Traffic Control Devices Order, amendment

Regulation 49/2012
Registered May 3, 2012

Manitoba Regulation 264/88 amended

MR-166

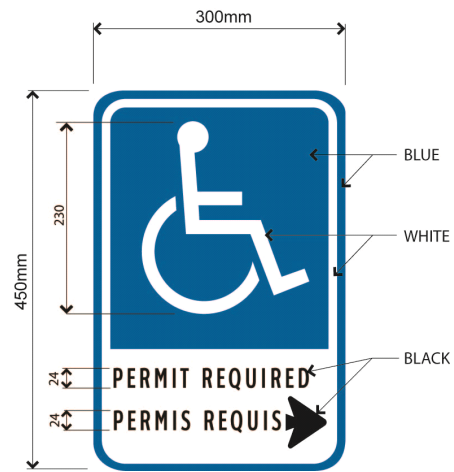
Disabled Designation sign (MR-166 and MR-166B)

65.24(1) A "Disabled Designation" sign may be used to indicate to drivers that a disabled parking permit is required in order to use the curb space delineated by the sign.

65.24(2) A "Disabled Designation" sign must

- (a) be rectangular in shape and erected so that the long dimension is vertical;
- (b) be not less than 300 mm in width and 450 mm in height;
- (c) be white in colour with a blue border and
 - (i) in the upper portion, display a symbolic person using a wheelchair in white within a blue background not less than 230 mm in height, and
 - (ii) in the lower portion, display
 - (A) the words "Permit Required" in black upper case letters not less than 24 mm in height, and
 - (B) a right- or left-pointing arrow in black to indicate the general area of the sign's application;
- (d) be available in a bilingual format as shown in the illustration labelled "MR-166B";
- (e) be reflectorized to show the same colour and shape by night as by day; and
- (f) bear the markings and have the dimensions illustrated in either of the following illustrations:
